Final Environmental Impact Report

Old Arcata Road Rehabilitation & Pedestrian/Bikeway Improvements

City of Arcata

November 16, 2021

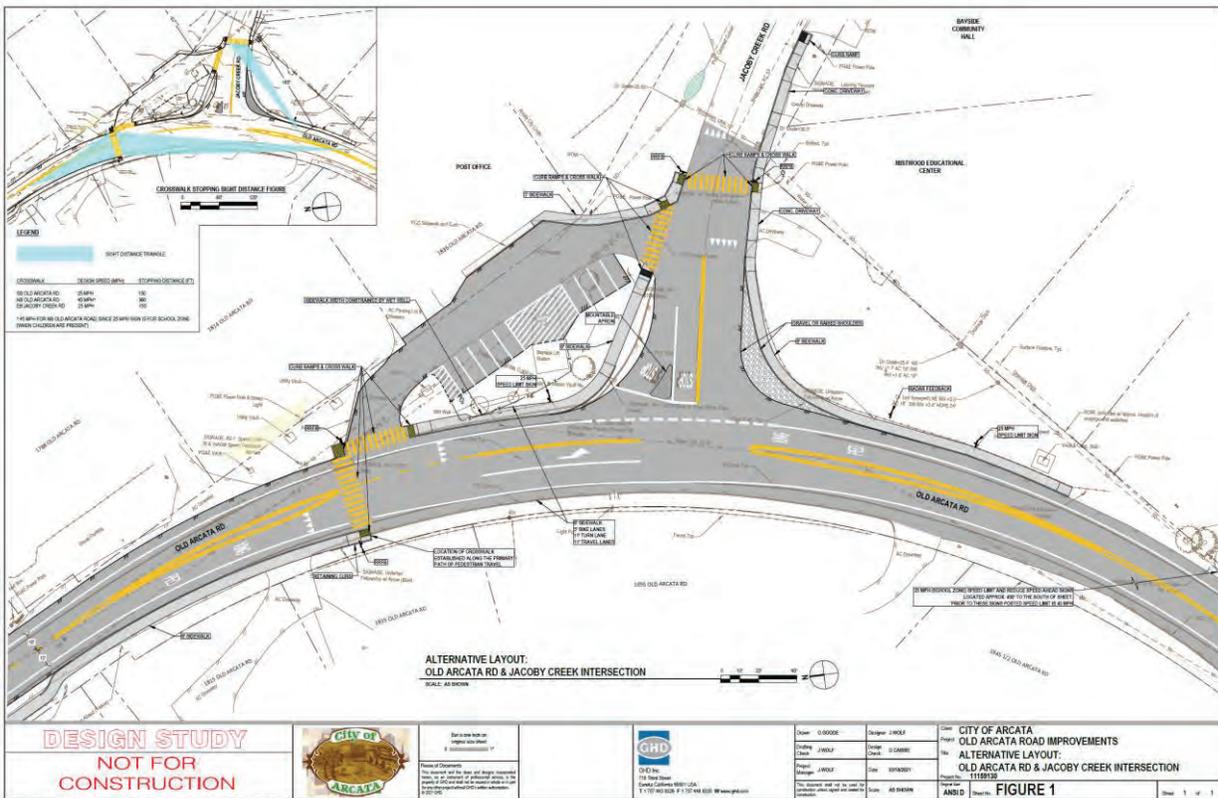
This is an alternative that was developed by the City of Arcata. Would the historical committee please consider requiring the project to choose alternatives with less impact the historic properties?

FIGURE 16
PROPOSED ROUNDABOUT AT
HISTORIC BAYSIDE CORNERS

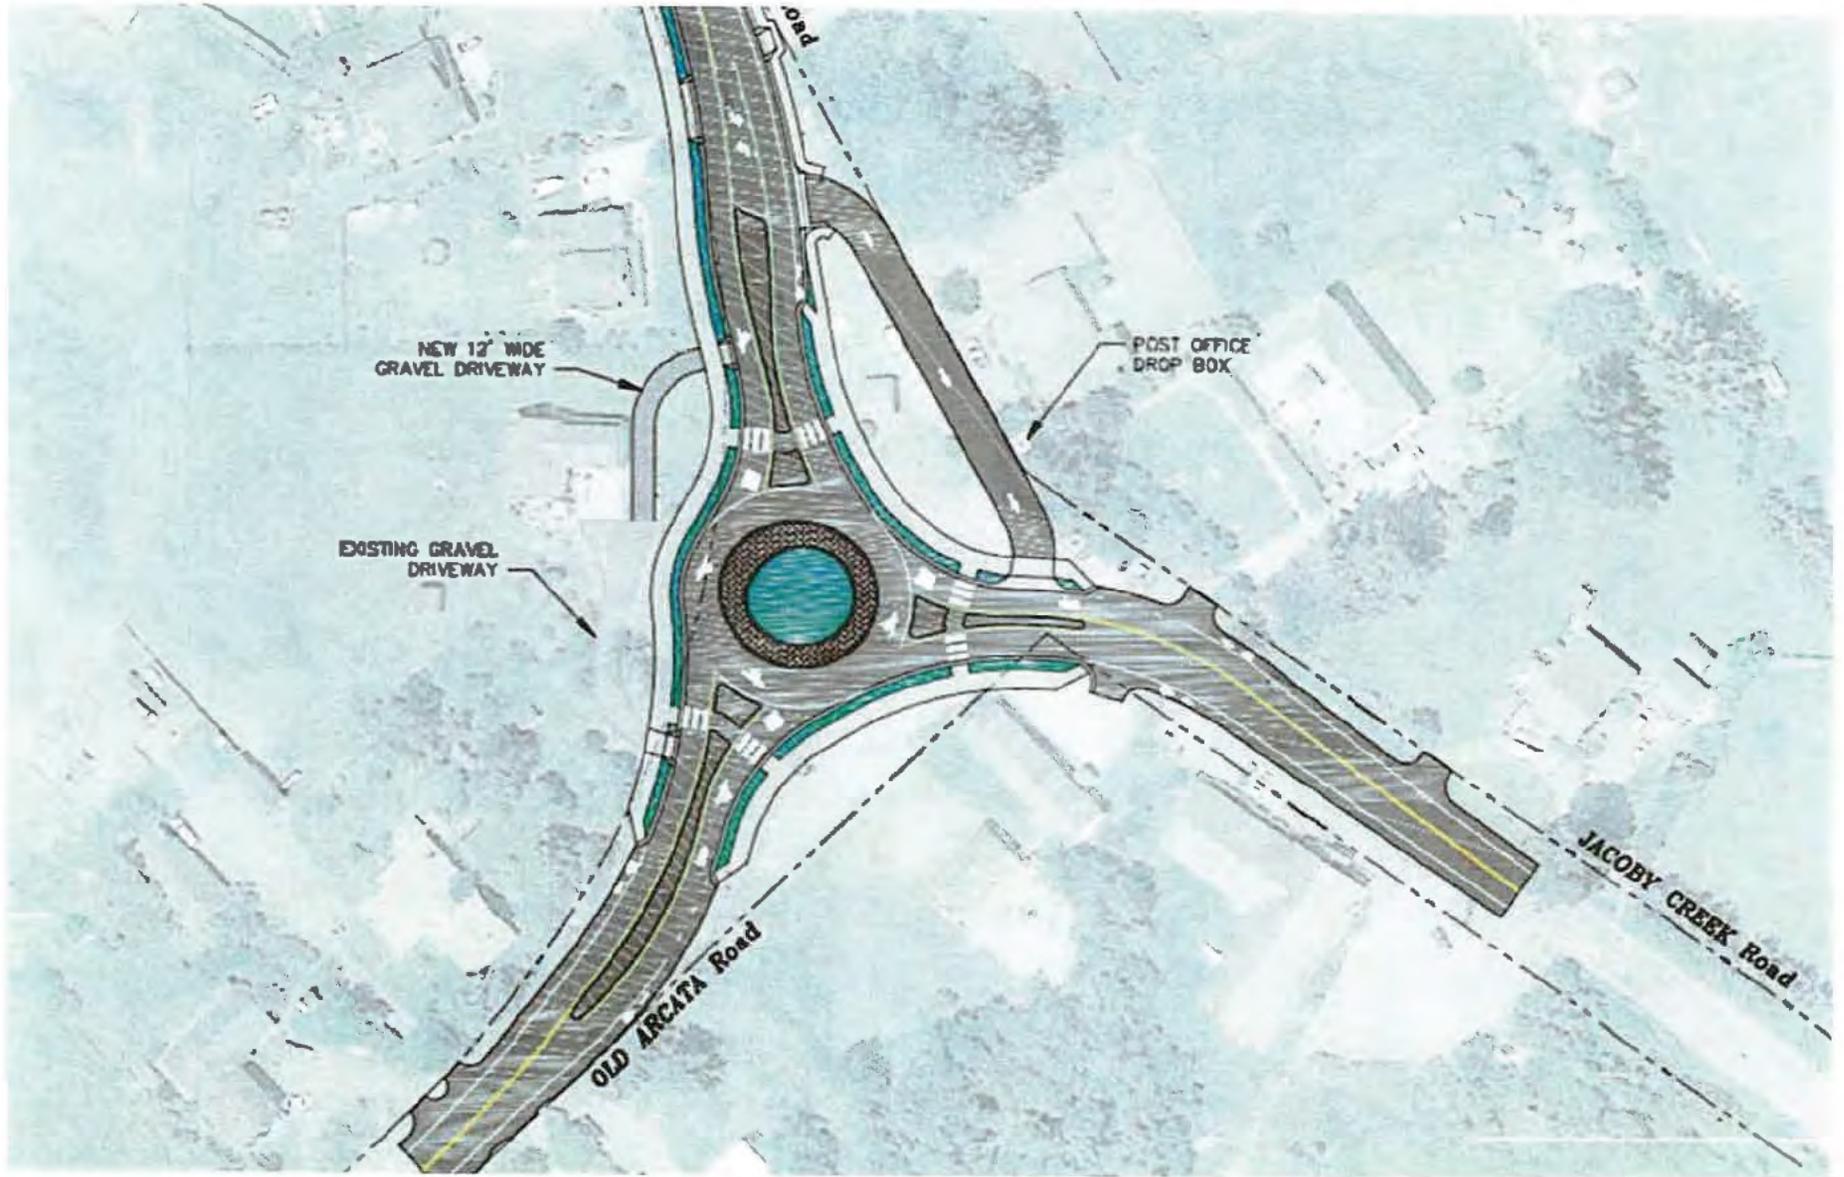
cumulative effect that is irreversible. Once the "Corners" is gone and replaced by a Roundabout the area will no longer reflect the historical development of the town and the old road that connected people to the historic nucleus of Bayside and the heart of the community. (See Figure 16)
